Addendum 10: Regulation No. 11

Revision 1 - Amendment 2

03 series of amendments - Date of entry into force: 11 June 2007

UNIFORM PROVISIONS CONCERNING THE APPROVAL OF VEHICLES WITH REGARD TO DOOR LATCHES AND DOOR RETENTION COMPONENTS

Model A

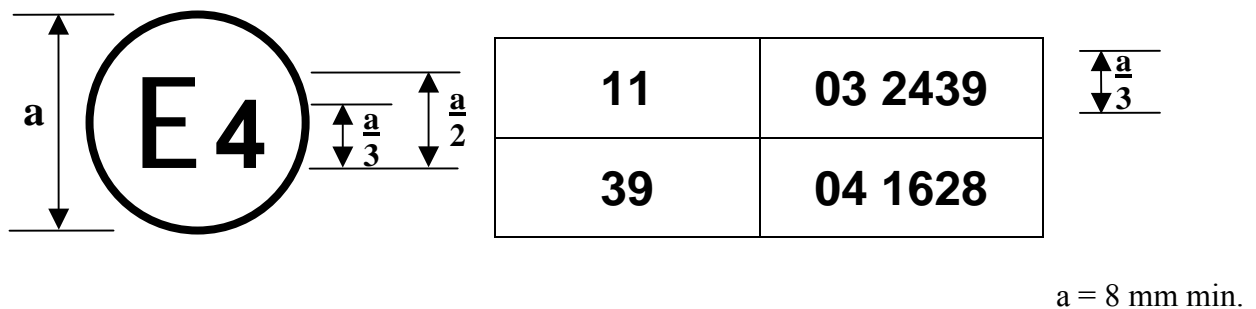
Annex 2, amend to read:

ARRANGEMENTS OF APPROVAL MARKS

The above approval mark affixed to a vehicle shows that the vehicle type concerned has, with regard to door latches and door retention components, been approved in the Netherlands (E 4) pursuant to Regulation No. 11, under approval number 032439. The first two digits of the approval number indicate that the approval was granted in accordance with the requirements of Regulation No. 11 as amended by the 03 series of amendments.

Figure 3-1 – Door Latch - Tensile Testing Fixture for Load Test One

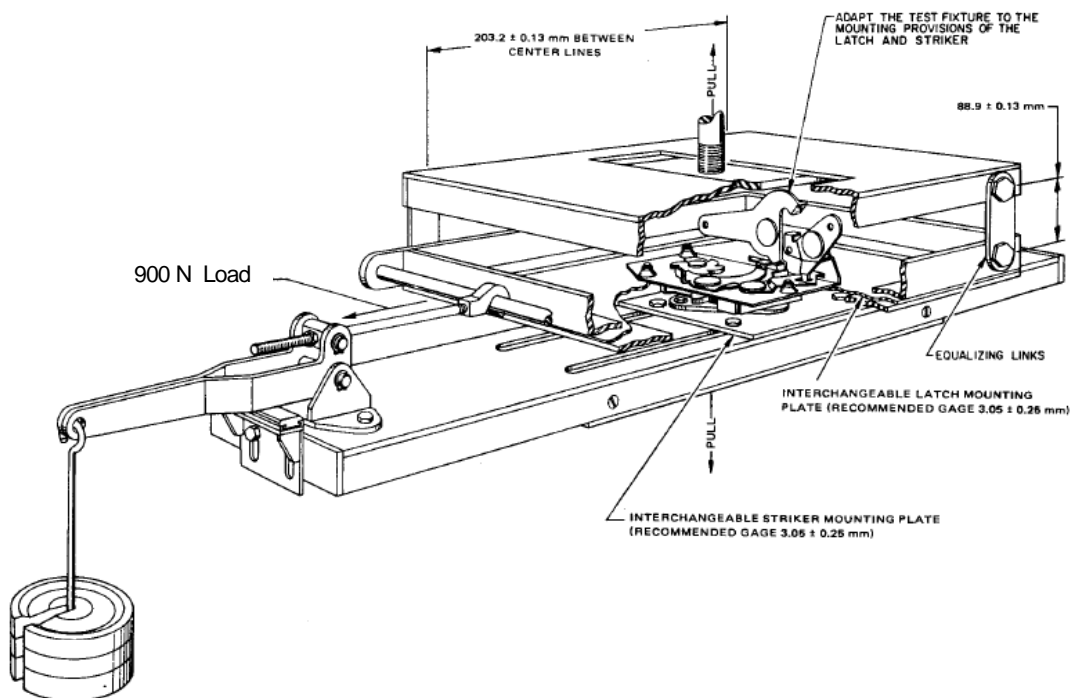
Annex 3, including its appendix, amend to read:

2.1.1. Equipment: Tensile testing fixture (see Figure 3-1).

Figure 3-2 – Door Latch – Tensile Testing Fixture for Load Test Two

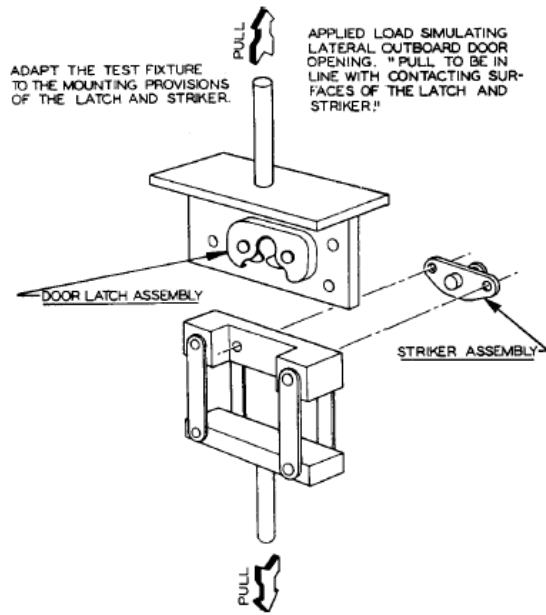
- 2.2.1. Equipment: Tensile testing fixture (see Figure 3-2).

Figure 3-3 - Door Latch – Tensile Testing Fixture for Load Test Three (Back Doors Only)

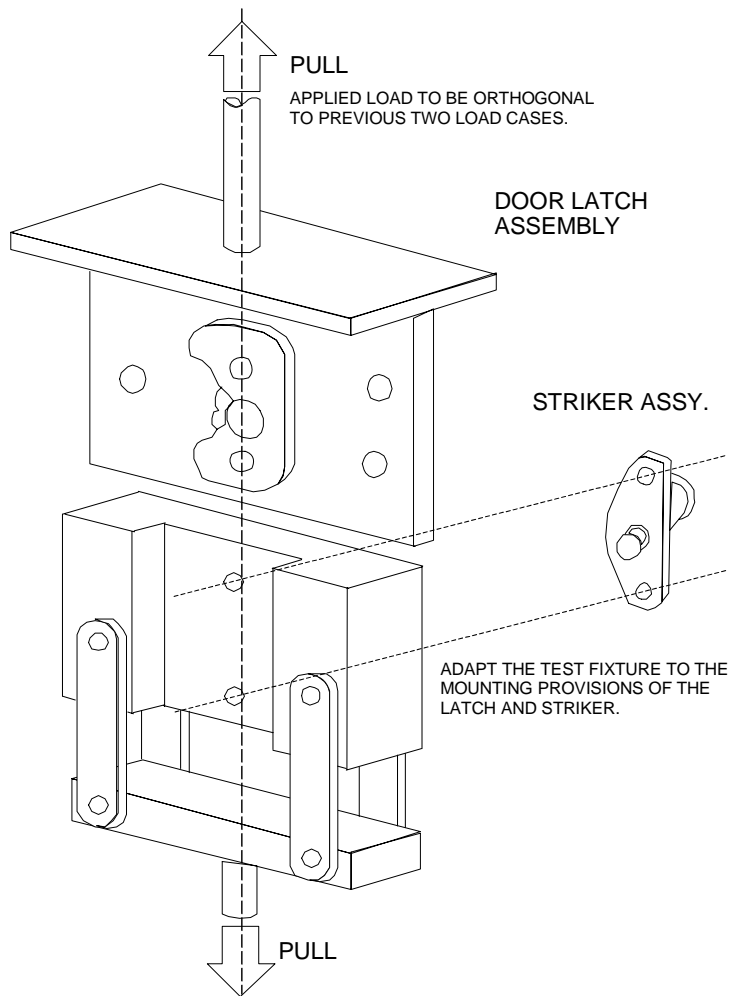
- 2.3.1. Equipment: Tensile testing fixture (see Figure 3-3).

Figure 3-4 – Door Static Load Test Directions"

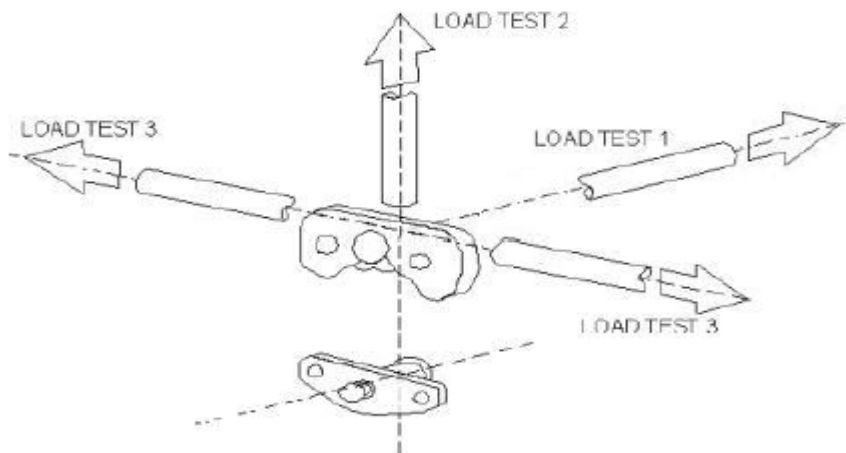
2.1.2.1.3. Apply the test load, in the direction specified in paragraph 6.1.1. of this Regulation and Figure 3-4, at a rate not to exceed 5 mm/min until the required load has been achieved. Record the maximum load achieved.

Figure 4-1 – Inertial Loading - Sample Calculation

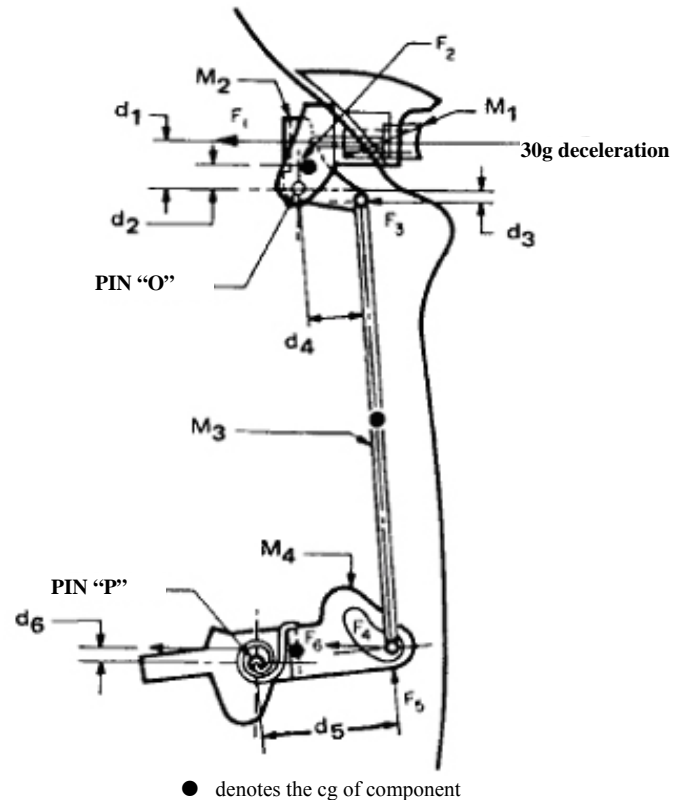
Insert new Annexes 4, 5 and 6, to read:

Given:
 Door latch system subjected to a 30g deceleration
 Average Push-Button Spring Output Force = 0.459kgf
 Pawl Spring Output Torque = 0.0459kgf m
 $a = 30g (m/s^2)$
 $F = ma = m \cdot 30g = m \cdot 294.2$

$$\begin{aligned} \Sigma M_o &= F_1 \times d_1 + F_2 \times d_2 - F_3 \times d_3 \\ &= 0.03 \times 31.5 + 0.681 \times 10.67 - 0.183 \times 4.83 \\ &= 7.33kgf \text{ mm} \end{aligned}$$

Figure 4-2 – Acceleration Pulse

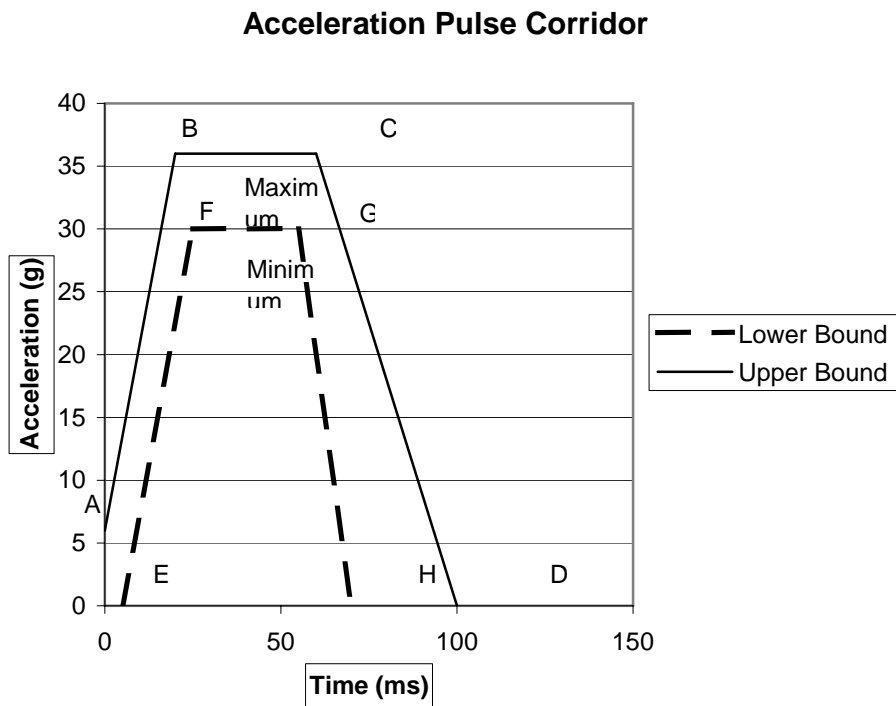
- 2.4. Test Operation for Options 2 and 3
- 2.4.1. A minimum acceleration level of 30 g shall be maintained over a period of at least 30 ms, while keeping the acceleration within the pulse corridor as defined in Table 4-1 and graphically shown in Figure 4-2.

Figure 4-3 - Vehicle Coordinate Reference System for Inertial Testing

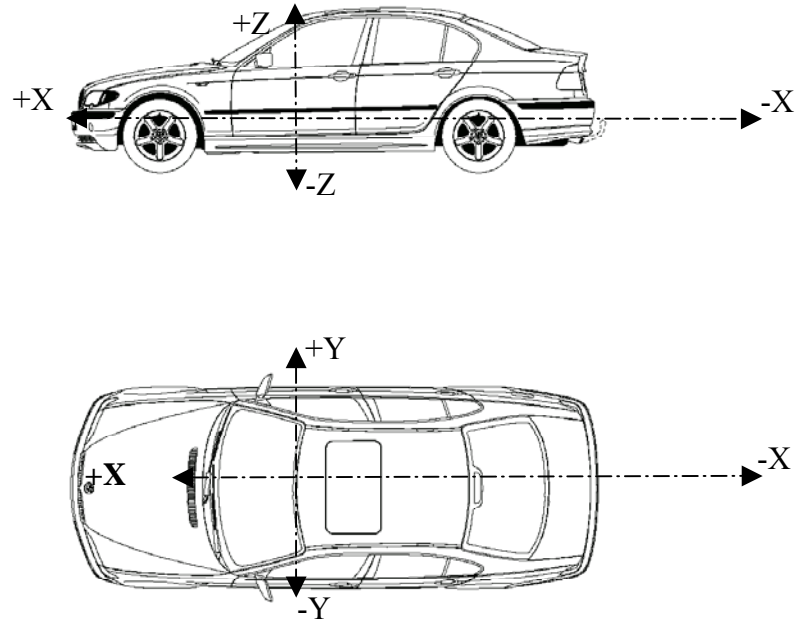
- 2.2.3. Test Directions (see Figure 4-3)
 - 2.2.3.1. Longitudinal Setup 1. Orient the vehicle or body in white so that its longitudinal axis is aligned with the axis of the acceleration device, simulating a frontal impact.

2.3.3. Test Directions (see Figure 4-3)

Figure 5-1 – Static test fixtures

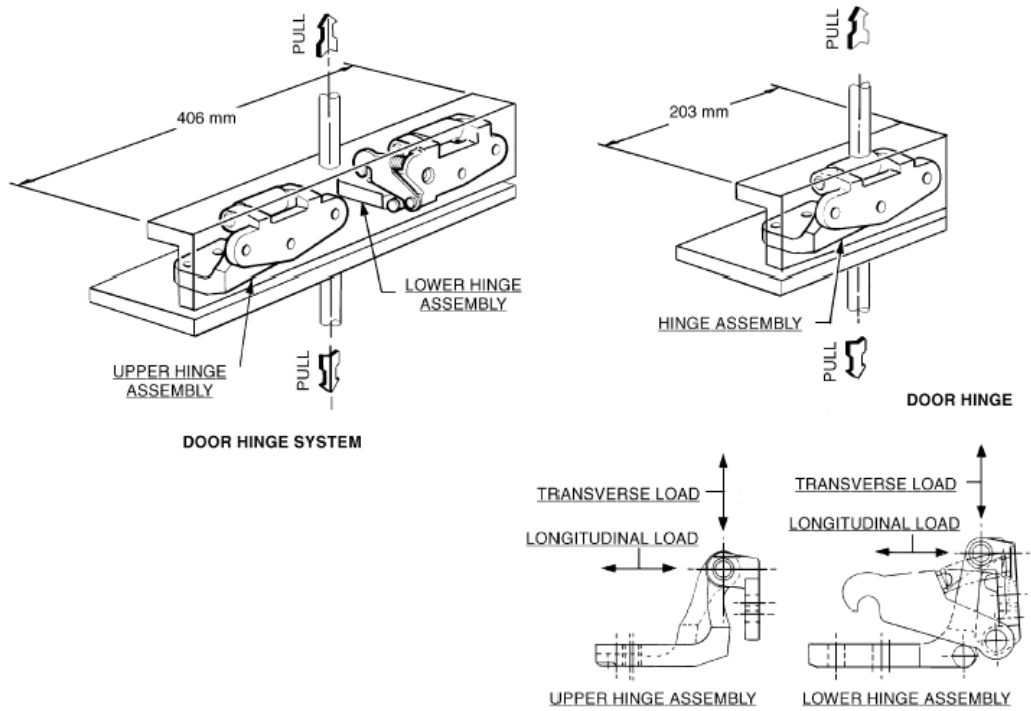
2.1.1.1.2. A typical static test fixture is illustrated in Figure 5-1.

Figure 5-2 – Static load test directions for back doors

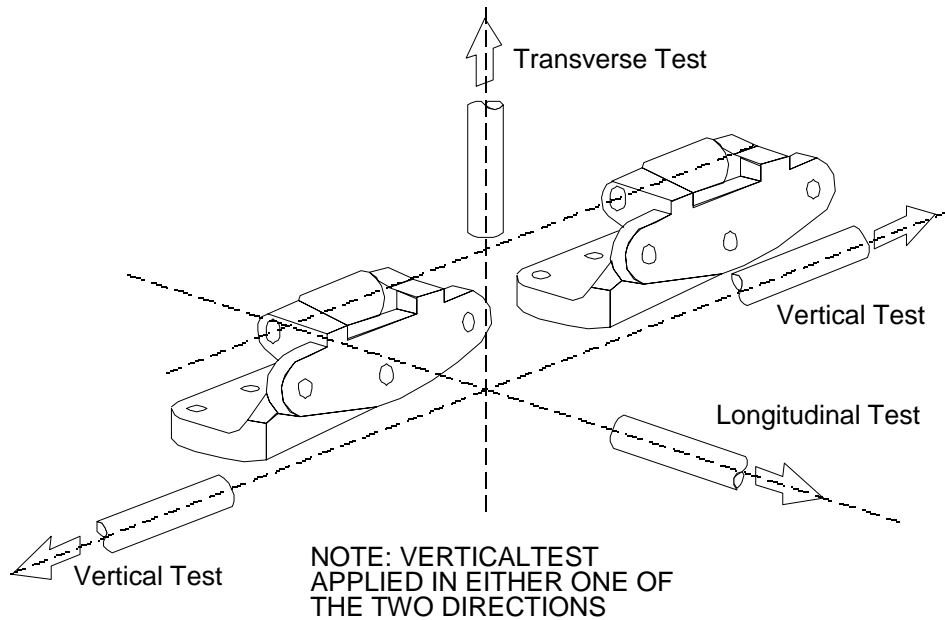
2.1.1.2.1. Attach the hinge system to the mounting provision of the test fixture. Hinge attitude must simulate vehicle position (door fully closed) relative to the hinge centreline. For test purposes, the distance between the extreme ends of one hinge in the system to the extreme end of another hinge in the system is to be set at 406 ± 4 mm. The load is to be applied equidistant between the linear centre of the engaged portions of the hinge pin and through the centreline of the hinge pin in the longitudinal vehicle direction. (see Figure 5-2).

Figure 6-1 – Sliding Side Door Full Vehicle Test Procedure
(Note: Sliding door is shown separated from the vehicle)"

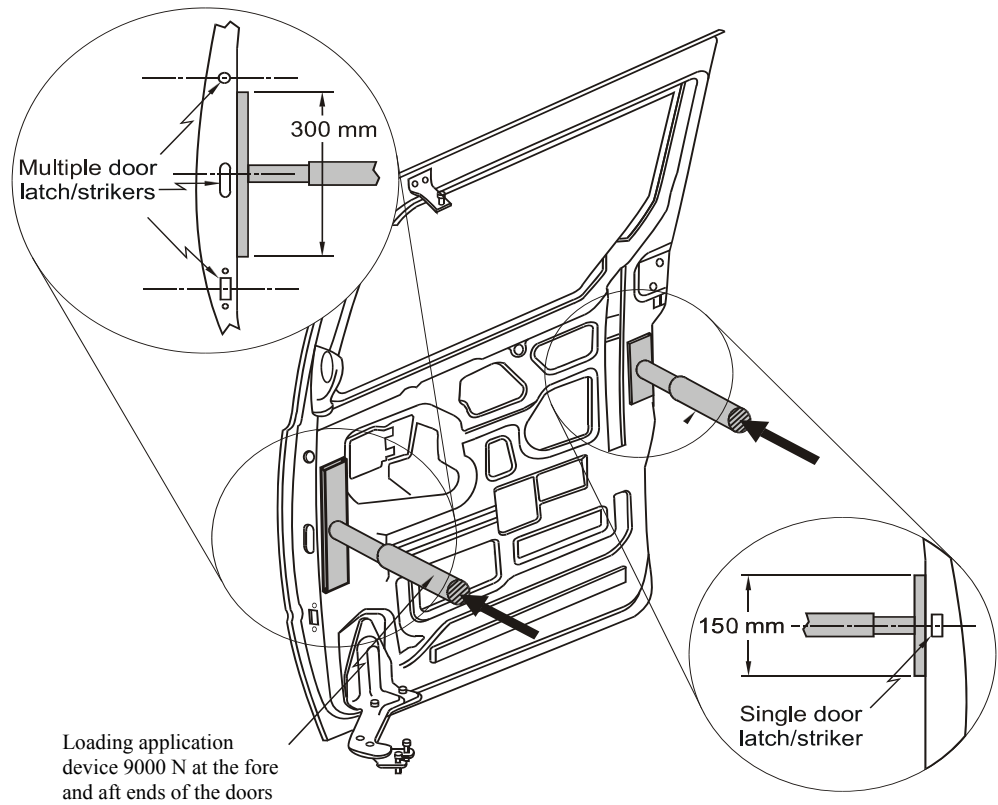
2.2. The test is conducted using two force application devices capable of applying the outward transverse forces specified in paragraph 6.2.4. of this Regulation. The test setup is shown in Figure 6-1. The force application system shall include the following:
